REMARKS

Docket/Appl'n No.: 2386.2013-000
Title: Dynamically Building Encapsulation ...
Inventors: Pradeep K. Kathail, et al.
Annotated Sheet

Prior Art
FIG. 1

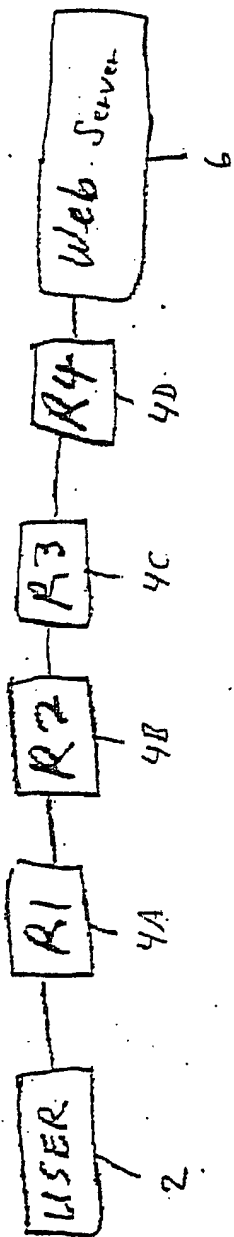
The Examiner objected to the drawings, indicating the view that FIGs. 1-5 should be designated as “prior art.” FIGs. 1-3 have been amended accordingly. However, Applicants disagree with the Examiner regarding the characterization of FIGs. 4A, 4B and 5 as being admitted arts. In the specification as filed, FIGs. 4A and 4B are each noted as relating to “an embodiment of the present invention.” (Page 6, lines 8-11). Applicants acknowledge that drawings FIGs. 4A and 4B correspond to FIGs. 4 and 4B, respectively, of US Patent 6,601,106, which was incorporated by reference in the instant application at page 4, lines 12-19.

FIGs. 1-3 are being amended to add the designation —Prior Art—.
